OCT 19 1973

Dockets Nos. 50-254 and 50-265

Change No. 9
Licenses Nos. DPR-29
and DPR-30

CHANGE NO. 8 TO THE TECHNICAL SPECIFICATIONS

FIGURE 3.5.1 MAXIMUM ALLOWABLE AVERAGE PLANAR LHGR APPLICABLE TO FUEL TYPE INITIAL CORE, TYPE I, II, III.

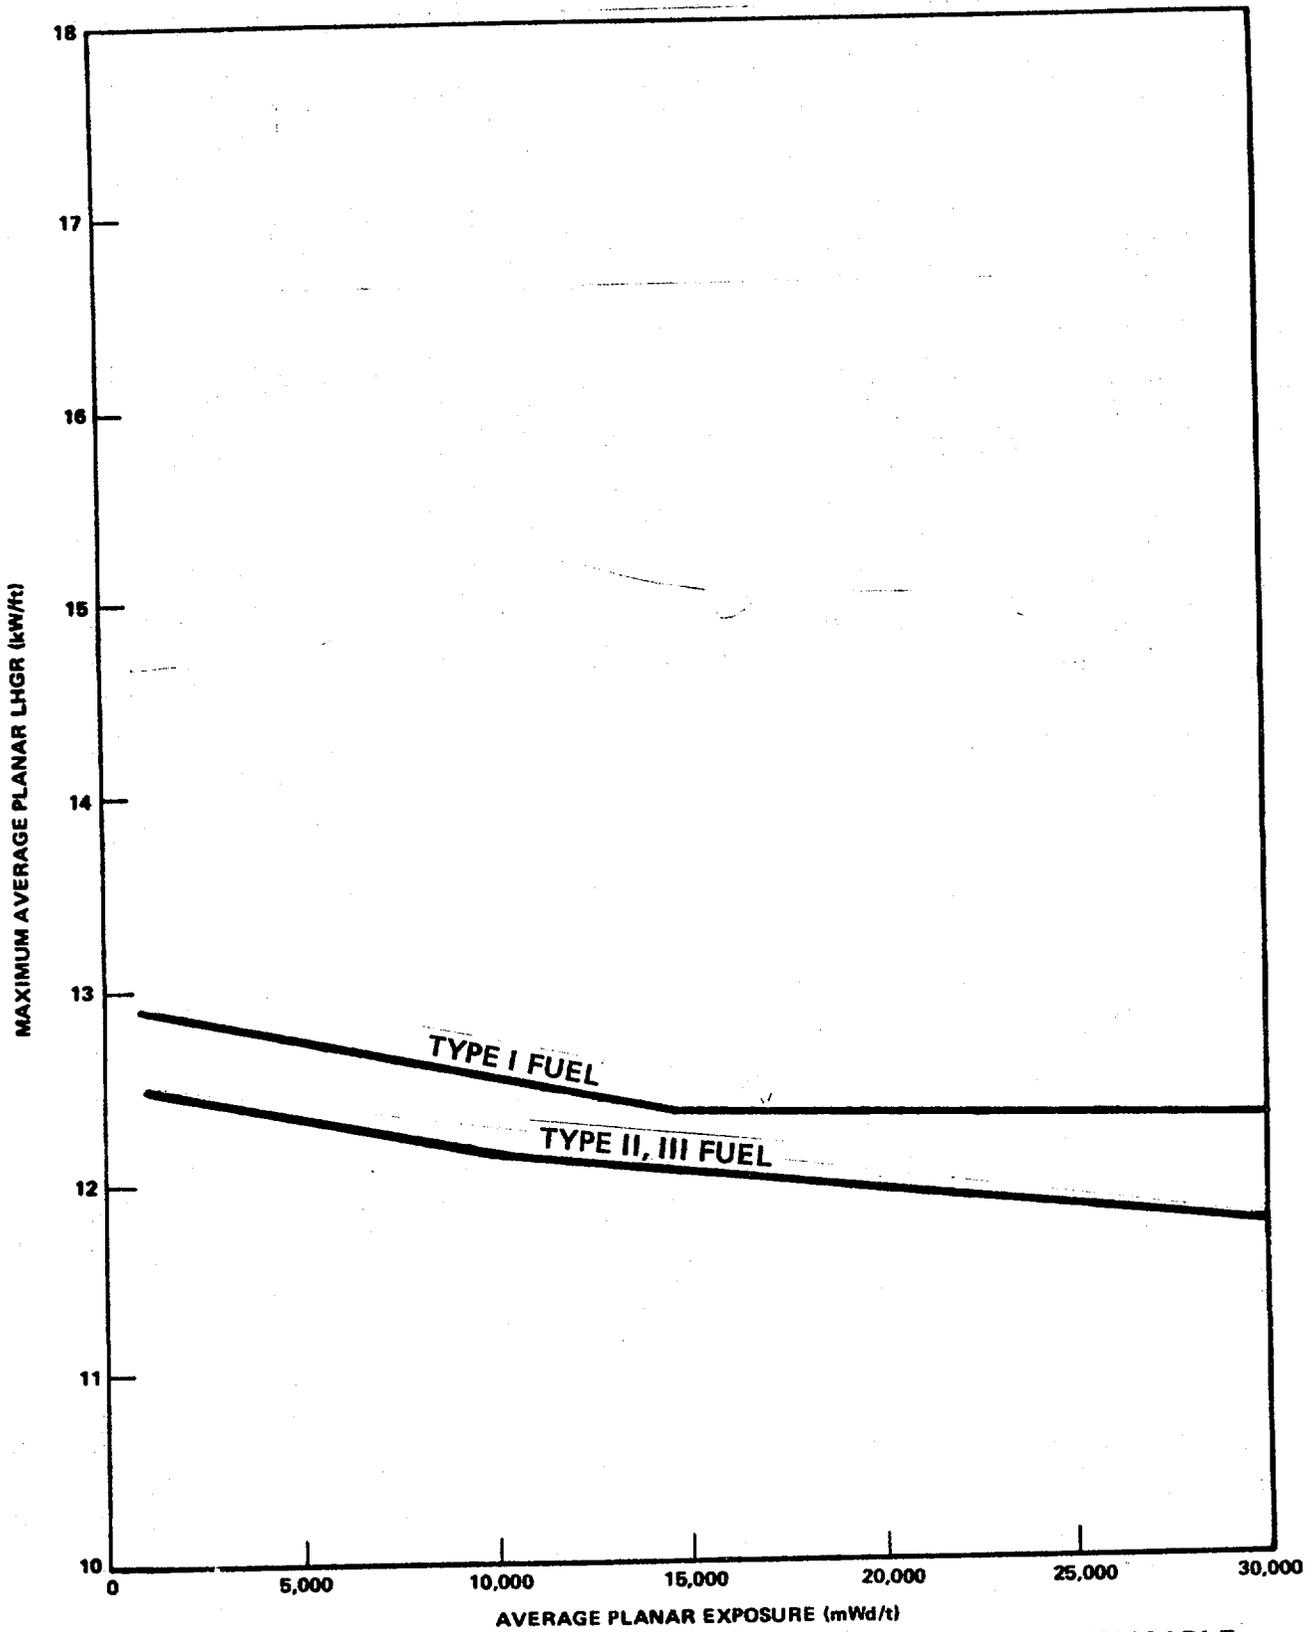
During steady state power operation, the average linear heat generation rate (LHGR) of all the rods in any fuel assembly, as a function of average planar exposure, at any axial location, shall not exceed the maximum average planar shown in Figure 3.5.1.

The maximum average planar LHGR shown in Figure 3.5.1 is the same as that shown on the curve labeled " γ " (gamma) on Figures 4-9K1, 4-9K2, 4-9L1 and 4-9L2 of the GE topical report "Fuel Densification Effects on General Electric Boiling Water Reactor Fuel," NEDM-10735, Supplement 6, August 1973 and is the result of the calculations presented in Section 4.3.4 of the same report. These
